Access Compliance Report

Public Rights-of-Way

(Curb Ramps)

Intersection ID: 10630	Main Street: E_SUGAR_CREEK_RD	Cross Street: EASTWAY_DR	Location: NW
ADA ID: 2FA5D4539DCC	Ramp Type: Para	Initial Pass/Fail: Fail	Overall Compliance: No
Severity Score: 12.5			
Codes/Mitigation Info/Possible Solution		Field Measurements/Component Compliance

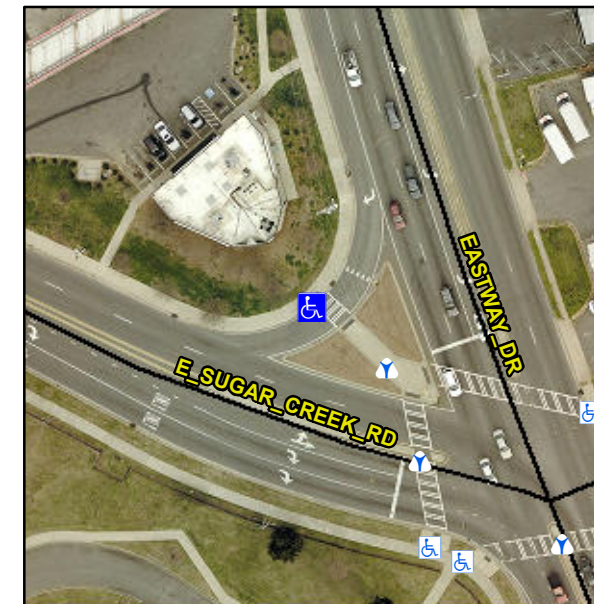
RT RP < 5%

R304.3.2

Compliance	Description	Data	Compliance	Description	Data
N/A	Ramp Length LT (in)	64.0	N/A	Ramp Length RT (in)	64.0
Yes	Ramp Width LT (in)	83.0	Yes	Ramp Width RT (in)	82.0
No	Ramp Slope LT (%)	10.2	Yes	Ramp Slope RT (%)	4.1
Yes	Ramp XSlope LT (%)	0.9	Yes	Ramp XSlope RT (%)	1.8
N/A	Landing Length (in)	N/A	N/A	DWS Provided?	N/A
N/A	Landing Width (in)	N/A	N/A	DWS Contrast?	N/A
N/A	Landing Slope (%)	N/A	N/A	DWS Length (in)	N/A
N/A	Landing X Slope (%)	N/A	N/A	DWS Full Width?	N/A
N/A	Landing Curb? (Y/N)	N/A	N/A	DWS Offset (in)	N/A
N/A	Shared Landing?	N/A			
N/A	Gutter Ponding?	N/A	N/A	Gutter Slope (%)	N/A
N/A	Gutter Lip Ht (in)	N/A	N/A	Gutter X Slope (%)	N/A
N/A	Painted X Walk1?	Yes	N/A	Painted X Walk2?	N/A
	X Walk 1 Direction	To SE		X Walk 2 Direction	N/A
N/A	X Walk 1 Width (in)	109.0	N/A	X Walk 2 Width (in)	N/A
	X Walk 1 Slope (%)	2.1		X Walk 2 Slope (%)	N/A
	X Walk 1 X Slope (%)	3.3		X Walk 2 X Slope (%)	N/A
N/A	Ramp inside XWalk1?	Yes	N/A	Ramp inside XWalk2?	N/A

Remove & Replace Entire Ramp.
